Service Bulletin #190

Ghostbusters, Aerosmith, Batman, Star Wars (All Models)

Capacitor Service Kit 502-7060-00

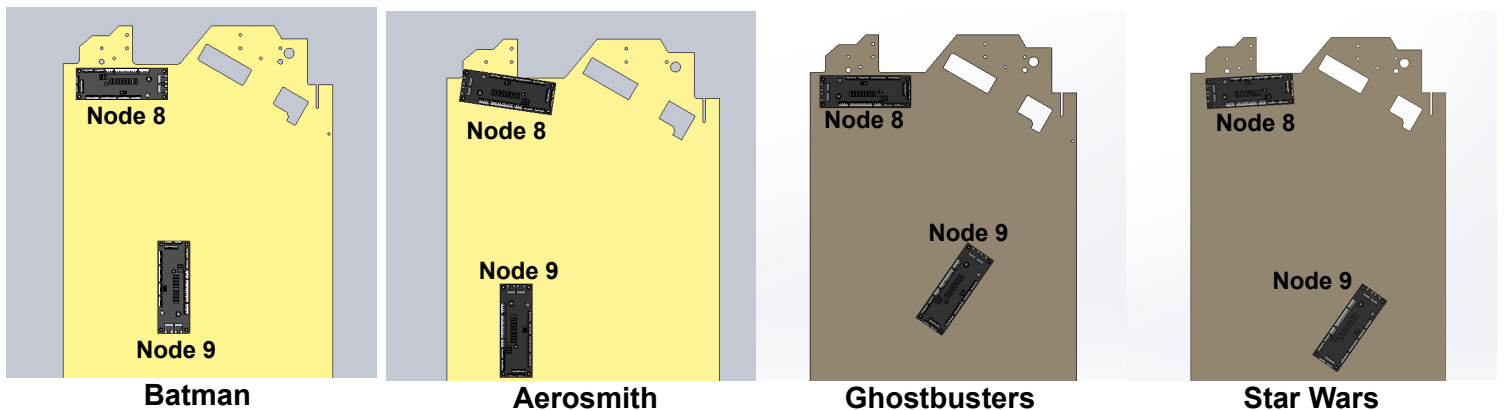
False switch activations during gameplay.

Electrical noise on the 48v power source.

Install the Capacitor Service Kit 502-7060-00.
